Clarification-I dated 05/08/2021 to Transportation of 105 MVA, 400/220 kV 1-Ph Transformer unit from New Wanpoh to Toshiba works at Rudraram, Telangana. Package No. N2JM/C&M/CS/24(21)

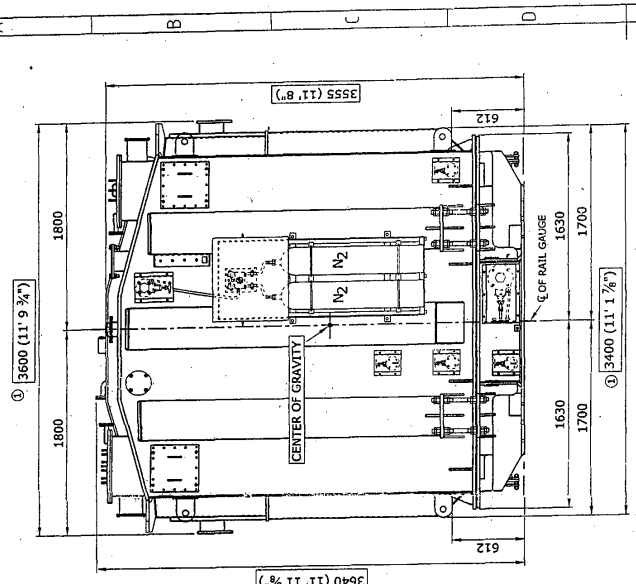
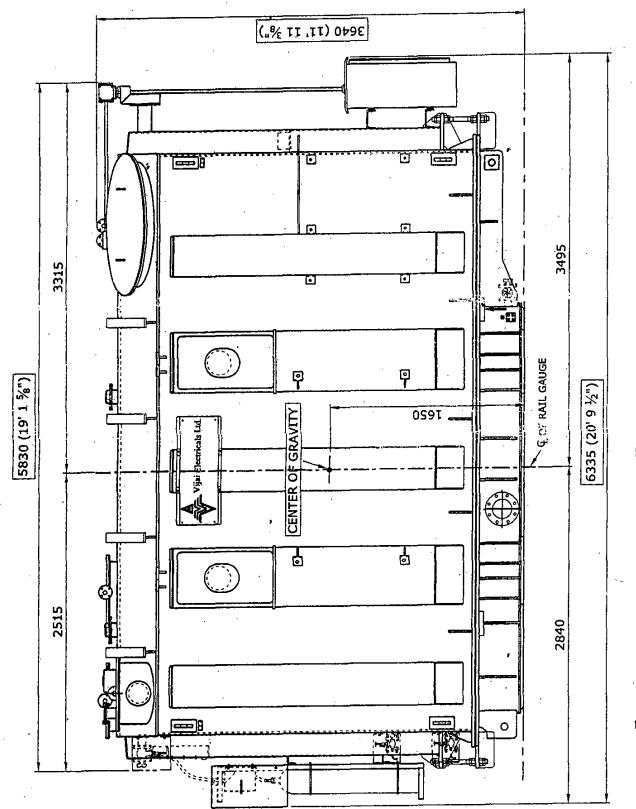
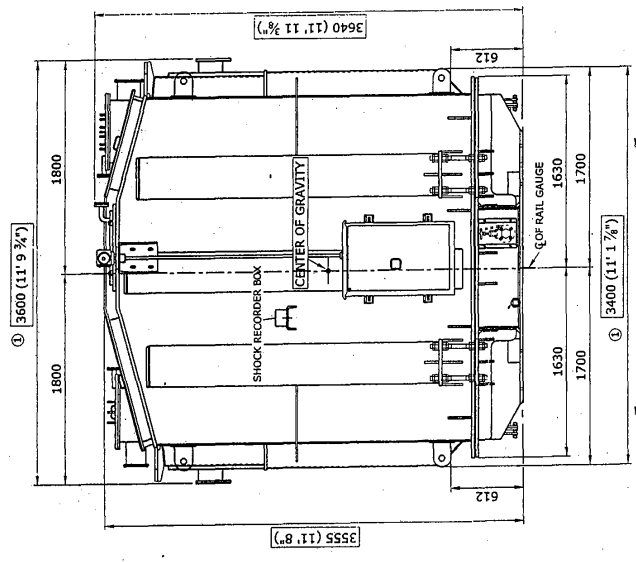
3.	General	Shipping dimensions & weight of the Main Tank is not mentioned in the NIT documents.	Please provide us the transport dimensions & weight of the Main Tank	The transportation sketch and name plate rating attached.
